IN no.: **IN-151 rev 1.0**

Date: **2021-12-16**

Device affected: **nRF52811-QFAA, nRF52811-QCAA and nRF52811-CAAA**

Description of change:

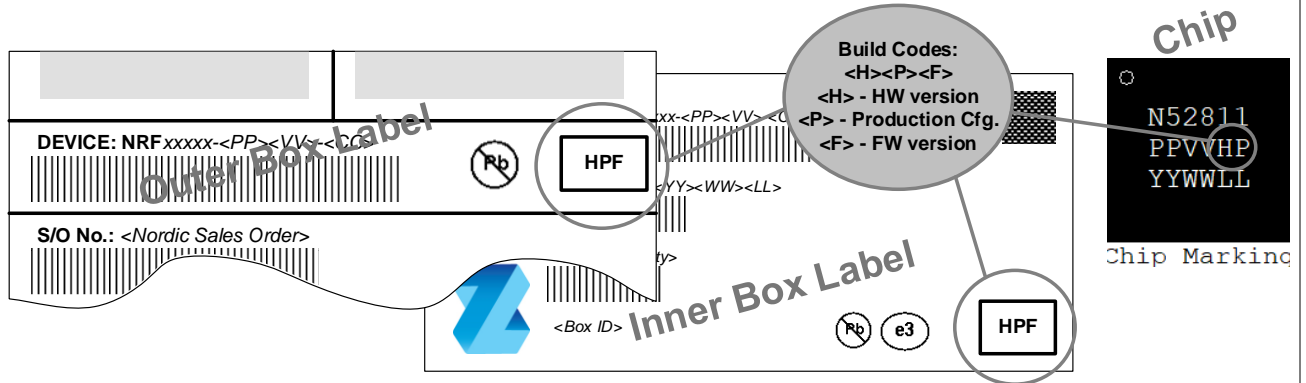
In factory state, the nRF52811 revision 2 comes with the access port protection enabled. An ERASEALL command via the control access port (CTRL-AP) is required to enable access.

In order to lock the device debug port, execute the following steps to enable access port protection:

1. Start with a CTRL-AP ERASEALL operation.
2. Program code compiled with MDK 8.43.0 or later, with ENABLE_APPROTECT defined.
3. Write Enabled (0x00) to UICR.APPROTECT
4. Perform a hard reset to protect the device. The programmed code from step 2 will write APPROTECT.FORCEPROTECT to Force (0x00).

To unlock the device debug port (for debugging etc.), execute the following steps to disable access port protection:

1. Start with a CTRL-AP ERASEALL operation.
2. Program code compiled with an MDK 8.43.0 or later, without ENABLE_APPROTECT defined.
3. Write HwDisabled (0x5A) to UICR.APPROTECT
4. Perform any reset to run the code. The programmed code from step 2 will open access port by writing to APPROTECT.DISABLE during start-up.

If an nRF52811 revision 2 is programmed with software compiled with a version of the MDK prior to release 8.43.0, the debug port will be locked. However, the APPROTECT.FORCEPROTECT will not be written to Force (0x0), and the errata workarounds implemented in the MDK may not be applied to revision 3. Thus, it is required to upgrade to the latest MDK (version 8.43.0 or later) to ensure correct behavior.
